ORIGINATION FORM

Proposed Revisions to a Standard Plans Index
(Please provide all information — Incomplete forms will be returned)

Index Number: 711-003
Sheet Number (s): 5 and 6
Index Title: Interchange Markings

SHEET
5 of 8

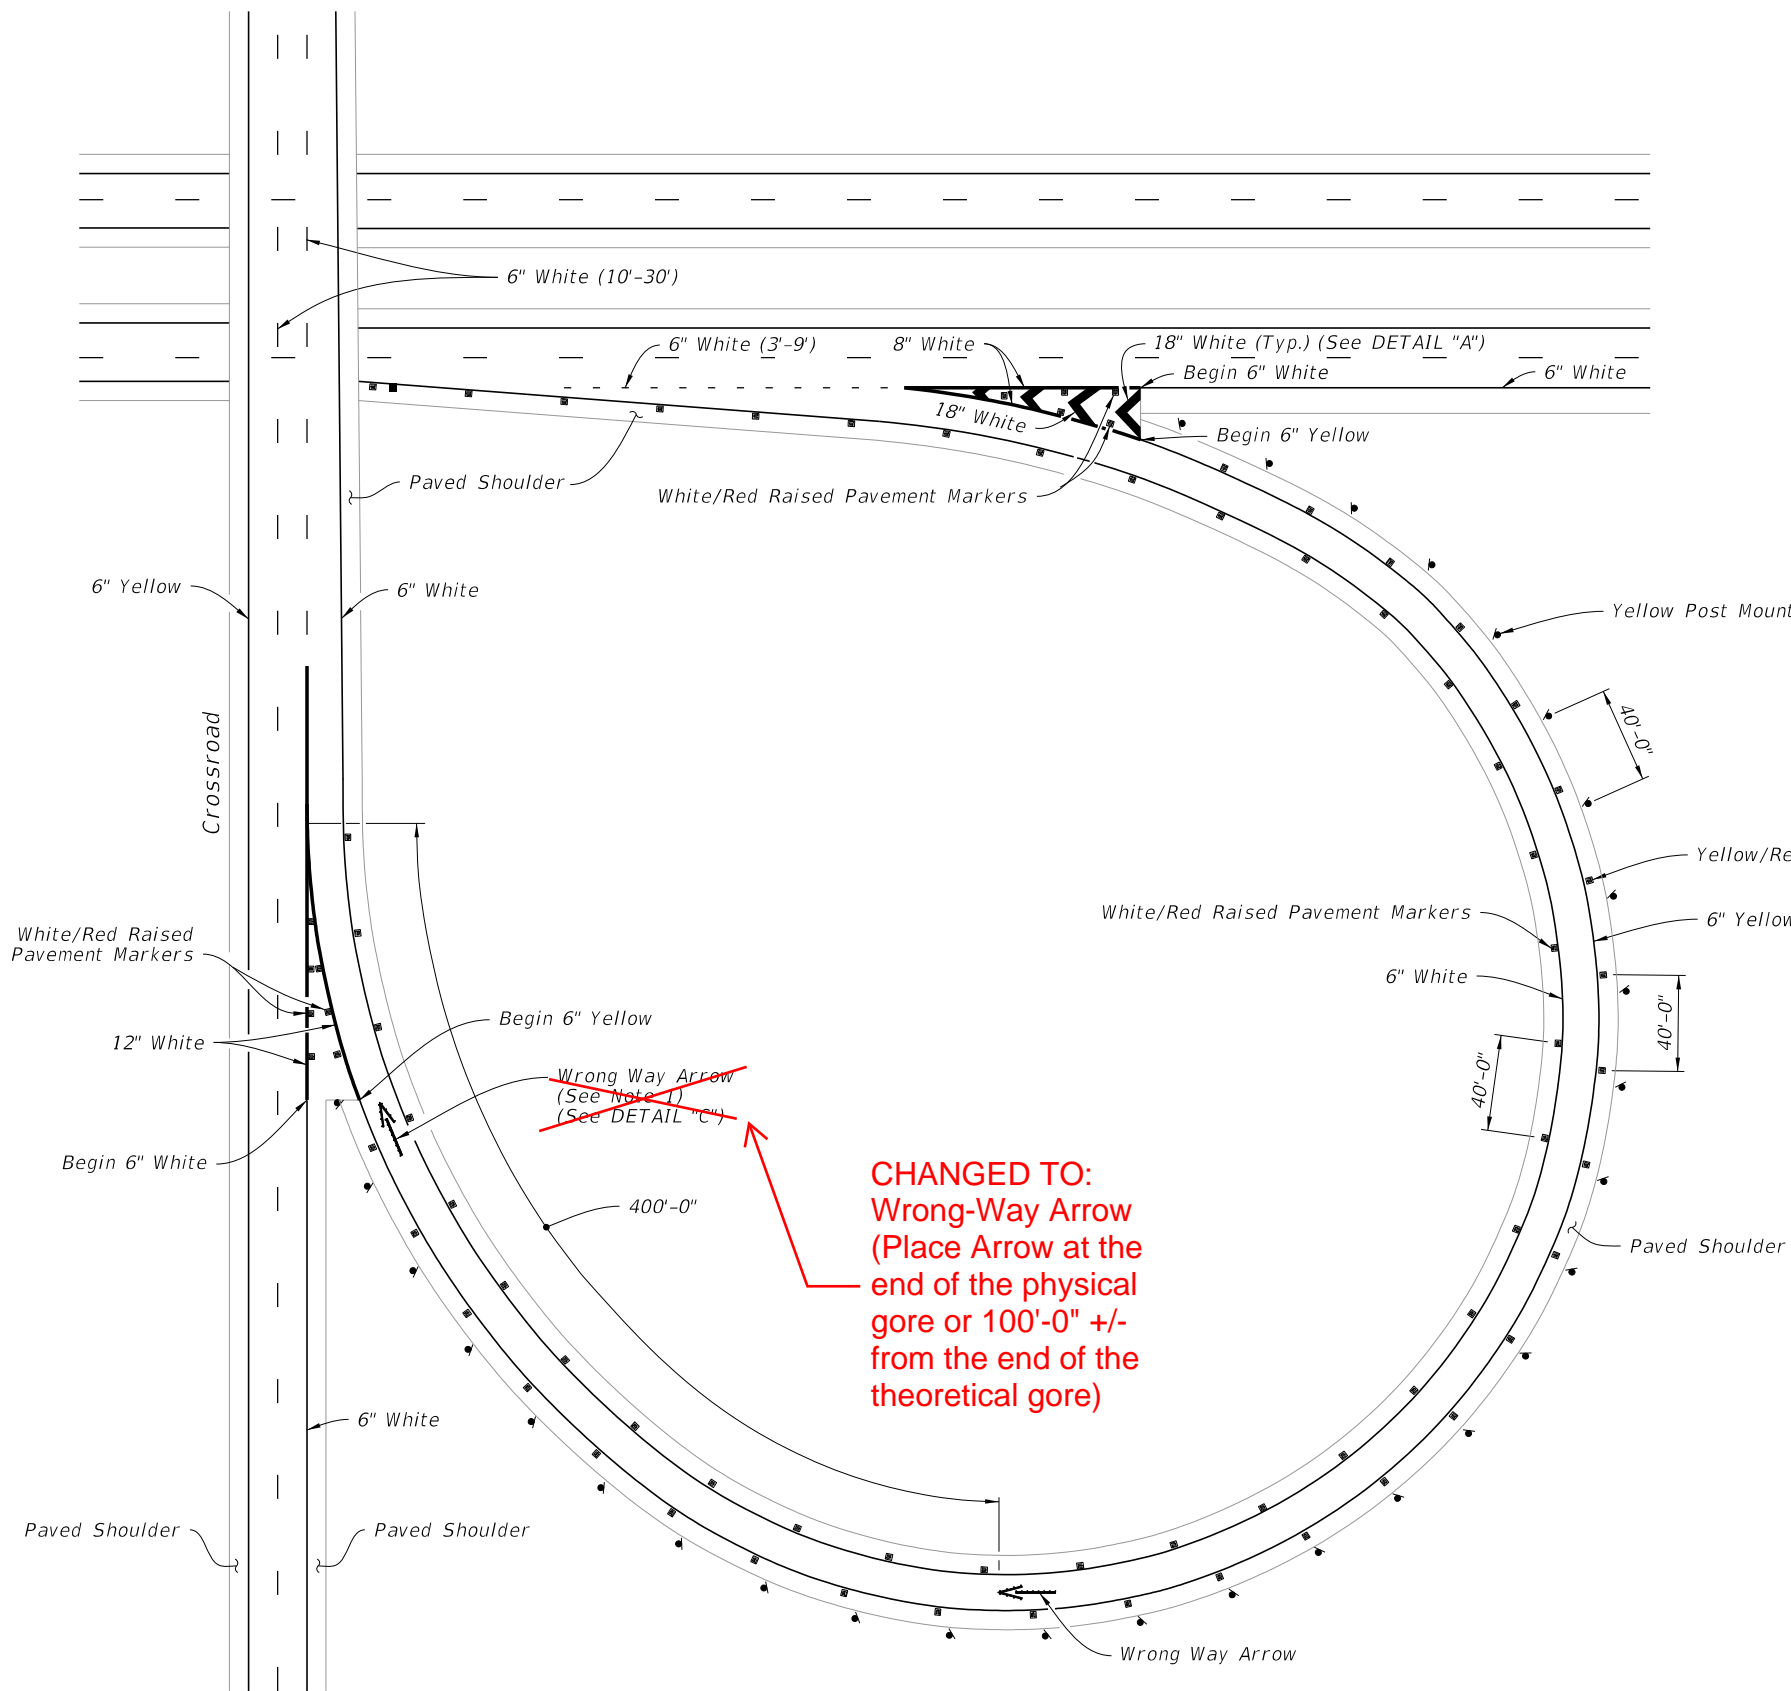
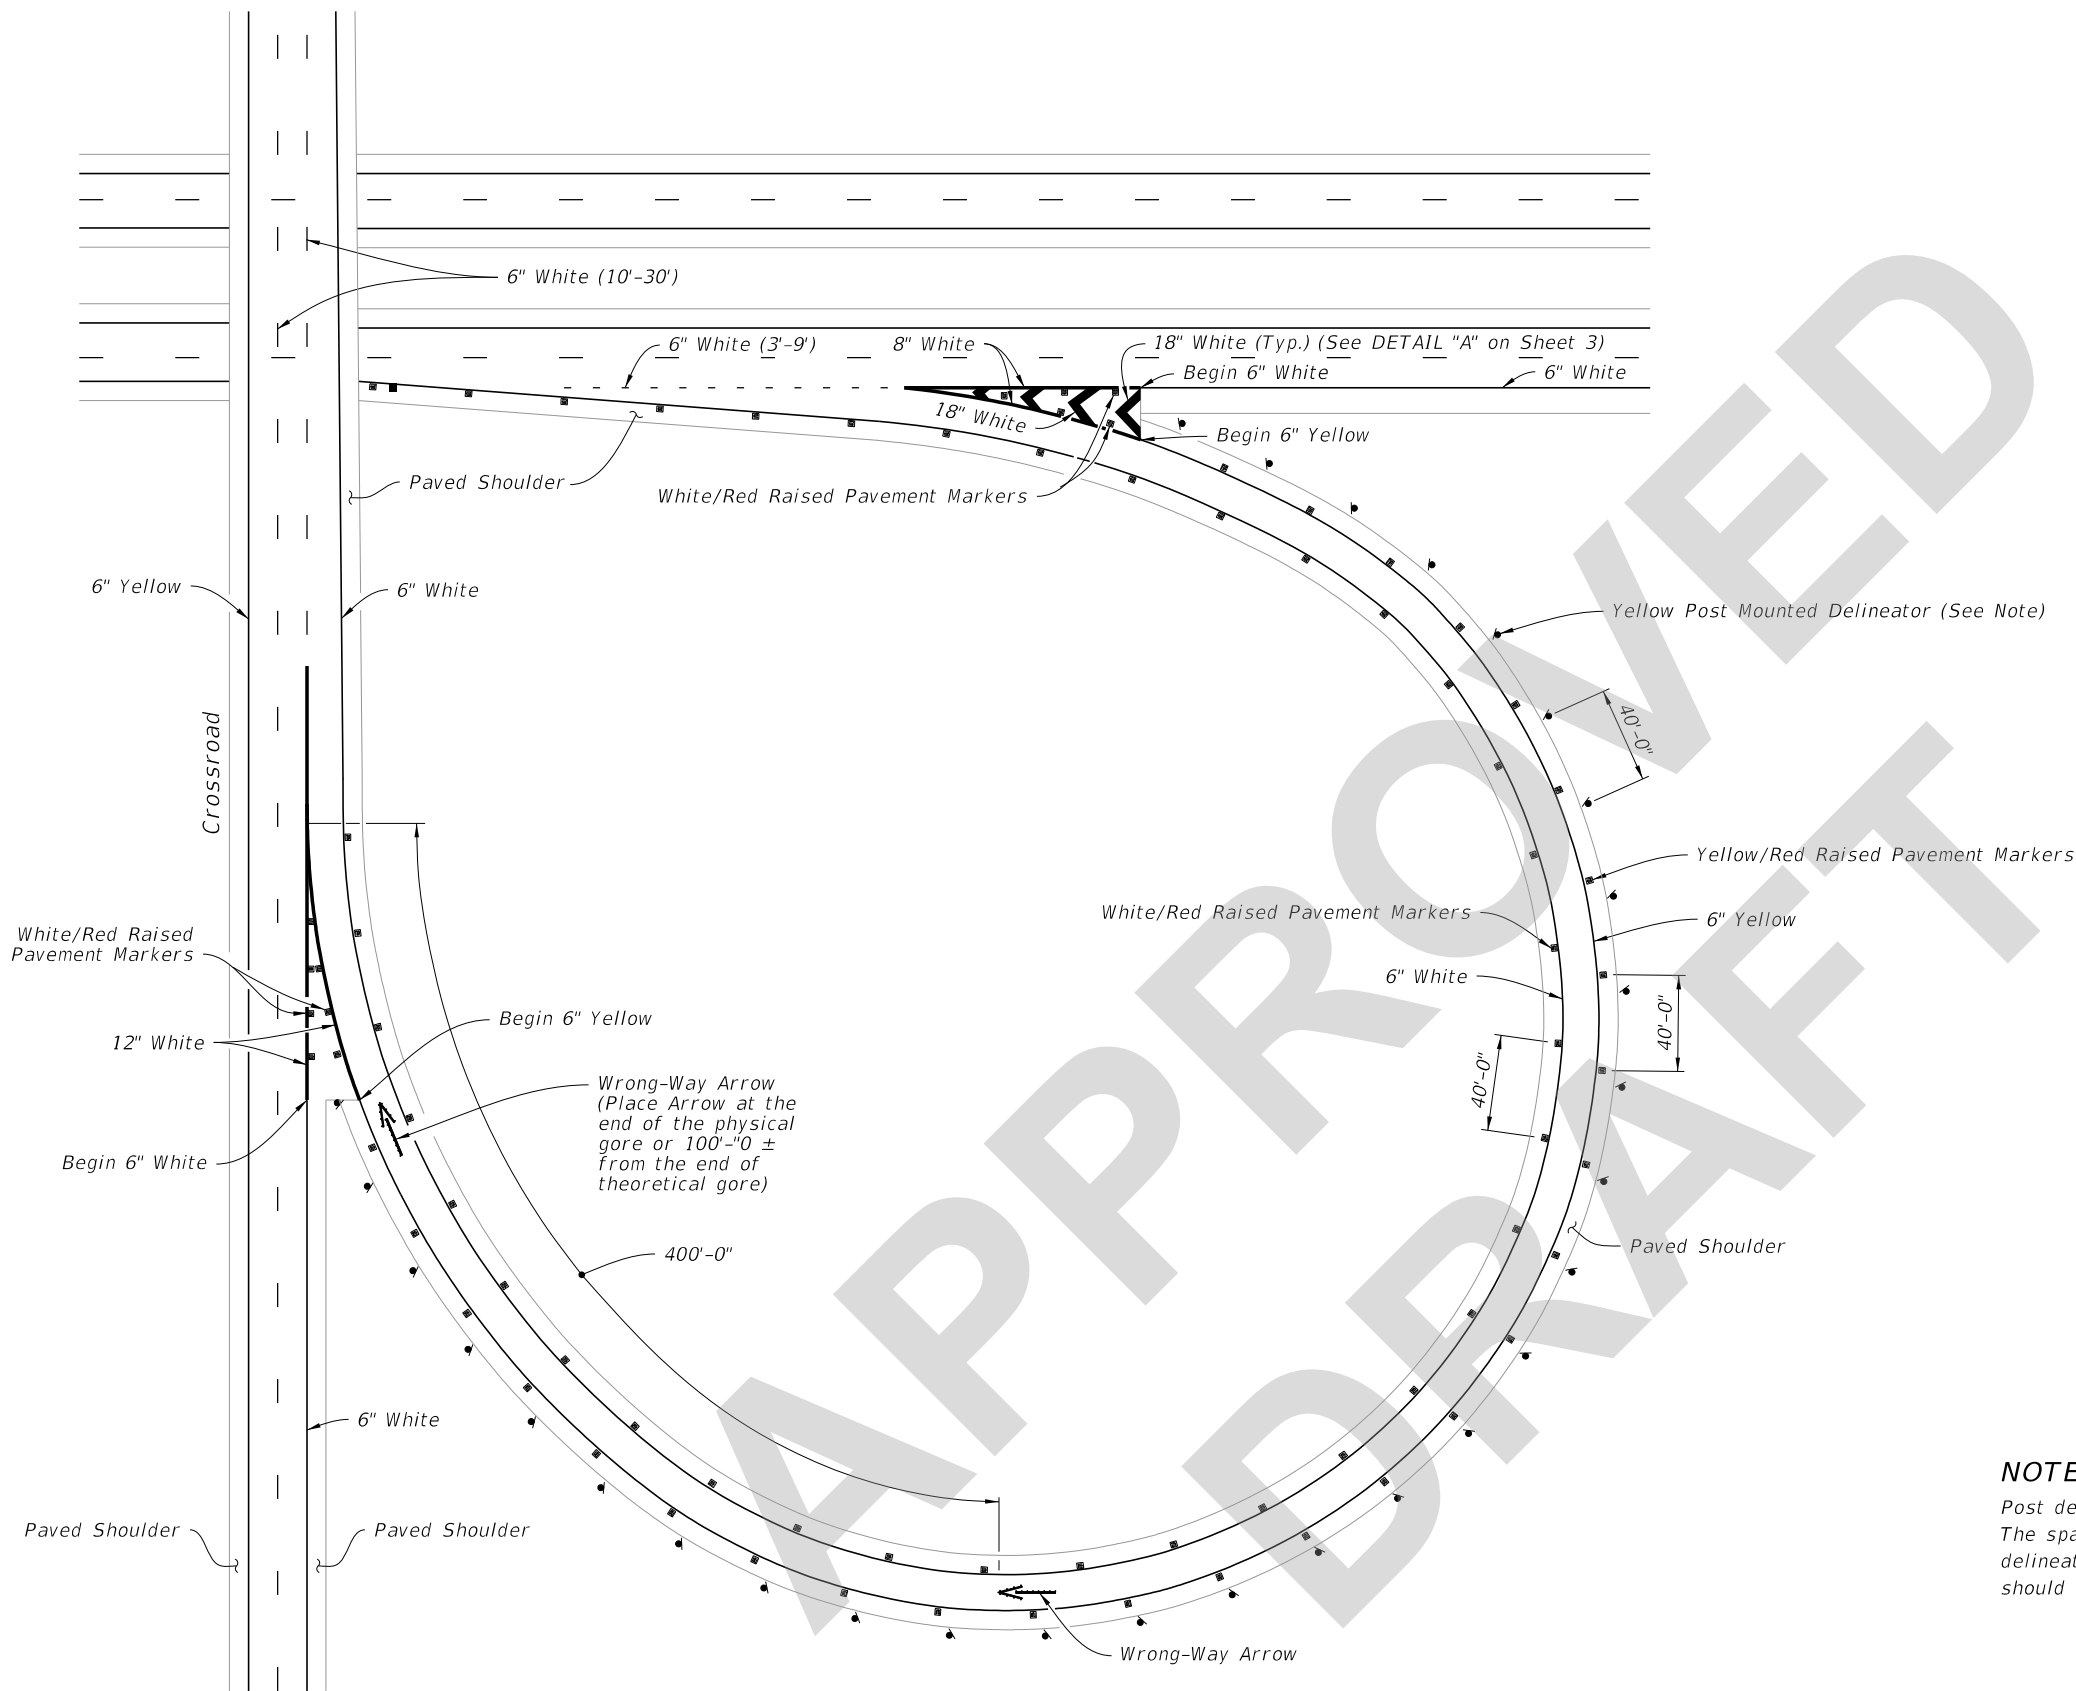
Sheet 5: Moved Detail "C" from sheet 5 to Sheet 3 of Index 706-001; Moved Note 1 to the Wrong-Way Arrow callout at the Gore; Deleted Note 2; Deleted the "See Note 3" reference from the Yellow Post Mounted Delineator callout.

~~Wrong Way Arrow
(See Note 1)
(See DETAIL "C")~~

**CHANGED TO:
Wrong-Way Arrow
(Place Arrow at the
end of the physical
gore or 100'-0" +/-
from the end of the
theoretical gore)**

- ~~1. Place the Wrong Way Arrow at the gore.~~
- 2. Post delineators spaced at 40' on curves of the entrance and exit of ramps. The spacing on the tangent portion of the ramp section is 300'-0". All delineators are to be setback 4' from shoulder break. Post delineators should not be discontinued in sections with guardrail.

TYPICAL CURVED EXIT RAMP ~~AND WRONG WAY ARROW~~

INDEX	SHEET
711-003	6 of 8

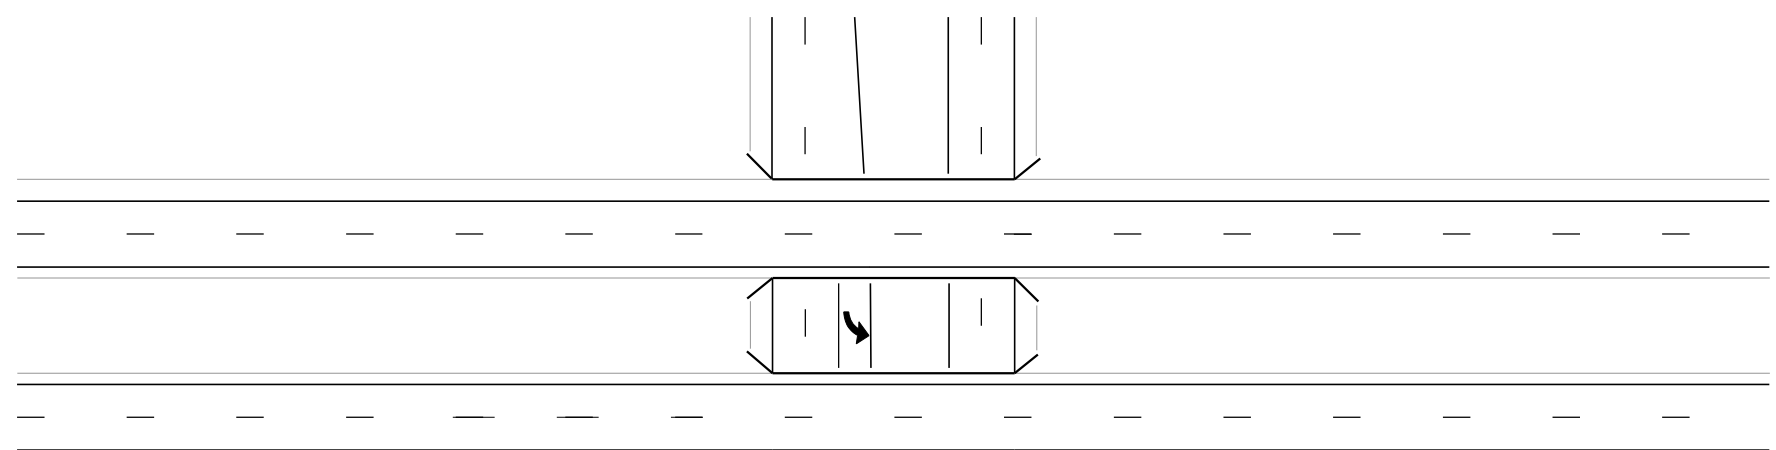
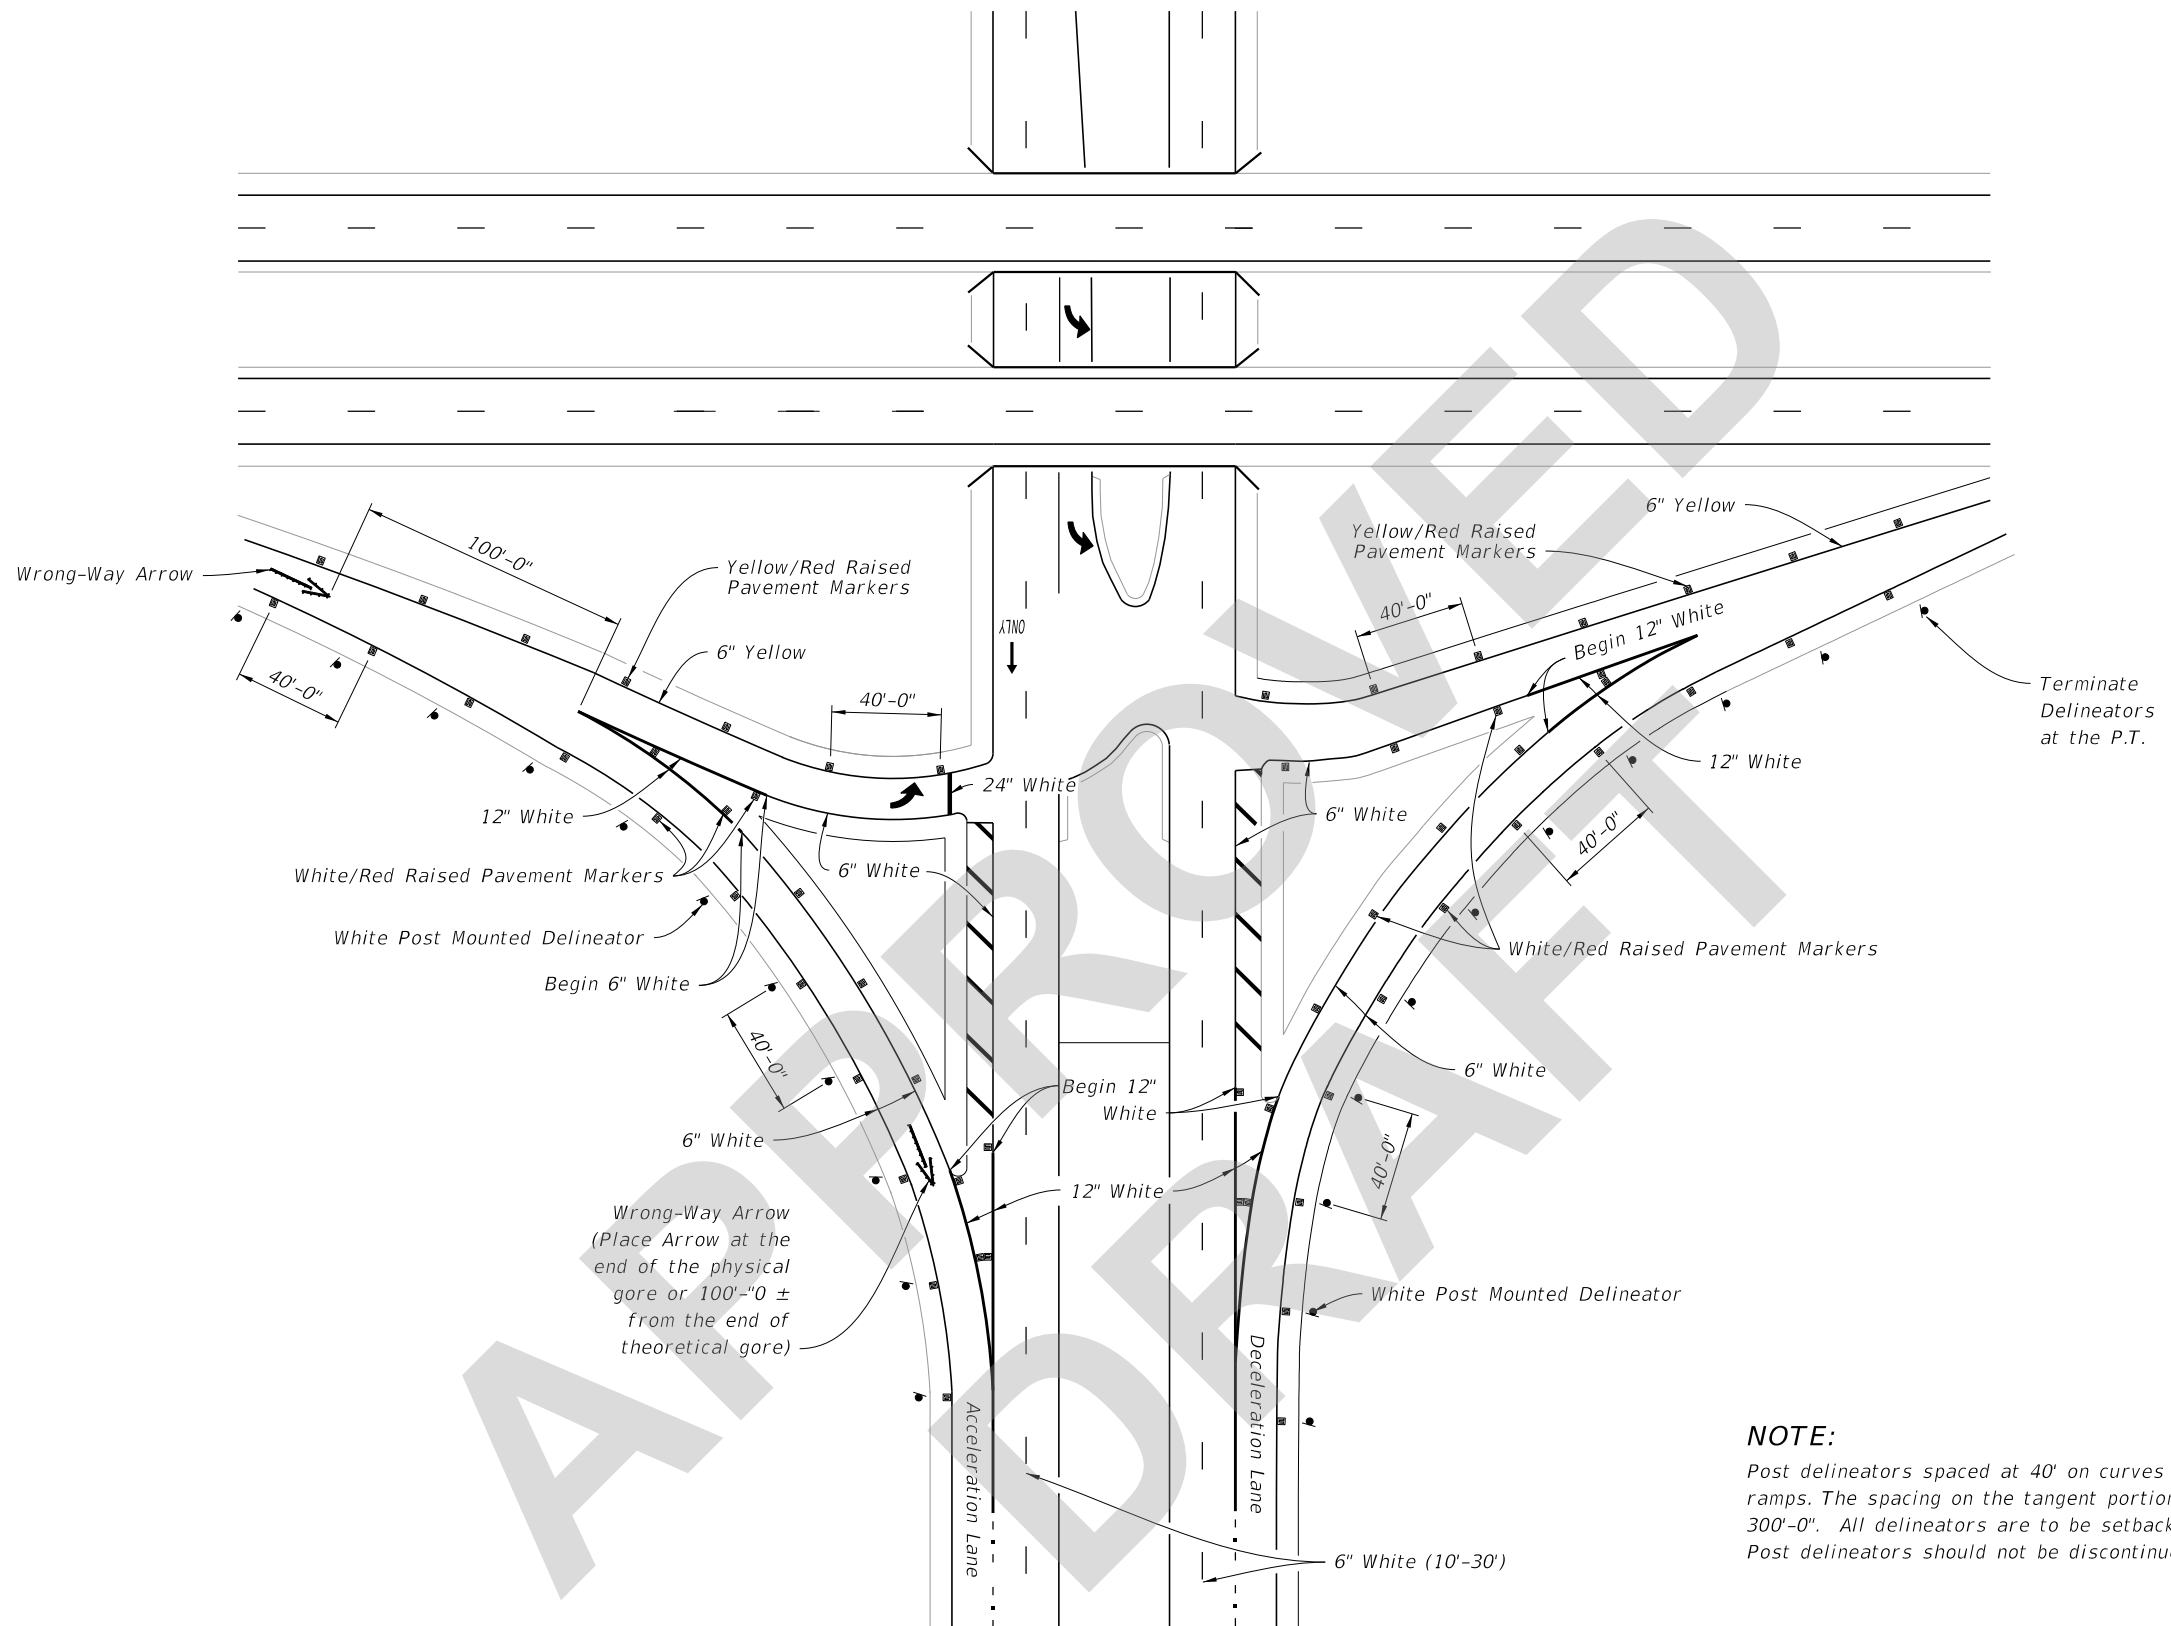
Sheet 6: Moved Note 1 to the Wrong-Way Arrow callout at the Gore; Deleted the note reference and the Detail"C" reference for the Wrong-Way Arrow callout on the off ramp.

~~Wrong-Way Arrow (See Note 1)
(See DETAIL "C", Sheet 5)~~

CHANGED TO:
Wrong-Way Arrow
(Place Arrow at the end of the physical gore or 100'-0" +/- from the end of the theoretical gore)

~~Wrong Way Arrow
(See Note 1)~~

- ~~1. Place the Wrong Way Arrow at the end of the physical gore or 100'-0" +/- from the end of theoretical gore.~~
- ~~2. Post delineators spaced at 40' on curves of the entrance and exit of ramps. The spacing on the tangent portion of the ramp section is 300'-0". All delineators are to be setback 4' from shoulder break. Post delineators should not be discontinued in sections with guardrail.~~
